UNITED STATES PATENT AND TRADEMARK OFFICE

APPLICATION NO.	FILING DATE	FIRST NAMED INVENTOR	ATTORNEY DOCKET NO.	CONFIRMATION NO.
09/619,665	07/19/2000	Shigeto Kamata	684.3049	2162

Office Action Summary

DETAILED ACTION

FIG. 13

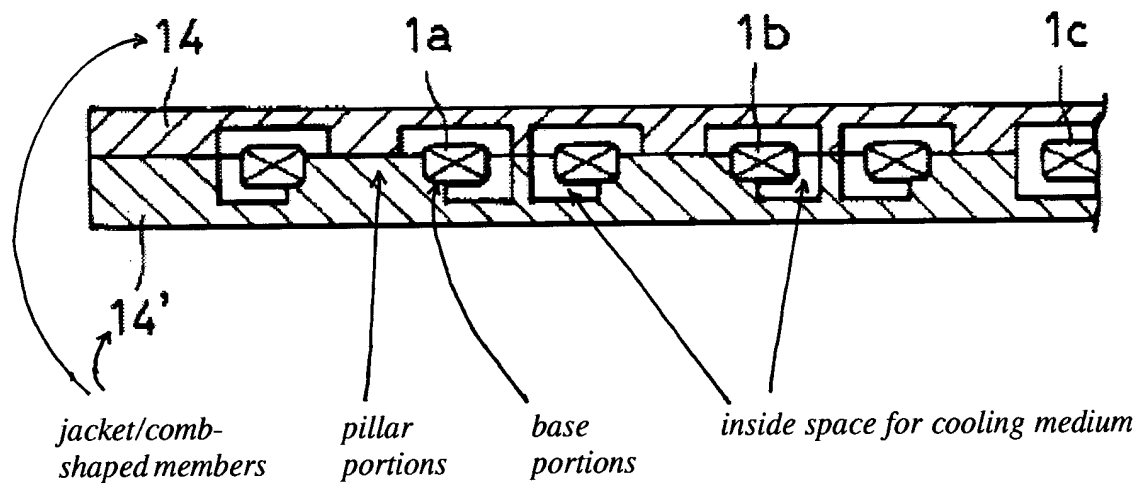
4. Claims 20-26 are allowed. Regarding claim 20, Kamata teaches a linear motor including magnets 3 (Fig.5) and coil holder or “jacket” 14 (Fig.10) formed in a comb-shape, plural coils 1a/1b/1c (Fig.13), plural “recessed” or “base portions” (not numbered, see Fig.13), and plural pillar portions 8a/8b/8c disposed in a first (longitudinal) direction of relative movement between the magnet and coil (Fig.13). Each coil is supported with respect to a second (transverse) direction by the “recessed” or “base” portions. However, there is no teaching or disclosure that the pillar portions are disposed along an outside periphery of the coils, i.e., that the pillar portions contact the coils on the outside periphery of the coils. As best seen in Fig.13, the pillar portions contact the inside periphery of the coils 1a/1b/1c of Kamata.

In response, the examiner points out that Fig.13 of Kamata discloses a comb-shaped member including base portions and pillar-like portions connecting the base portions. The base portions in Kamata comprise step-shaped indentations in the pillar portions. The base portions further support the coils 1a/1b/1c "in a floating manner," i.e., such that a space exists between either side of the coils and the jacket covers 14/14'. Cooling medium in the jacket can thus flow in the space, on both sides of the coils (c.5, lines 53-65).

Further, the coils are "fixed with respect to the driving direction" by the base and pillar portions and the pillar portions "sandwich" the coils. See c.5, lines 13-20 where in the first embodiment (Fig.3) a pair of cooling plates 42b are described as "sandwiching both sides of the [coil] row 42a."
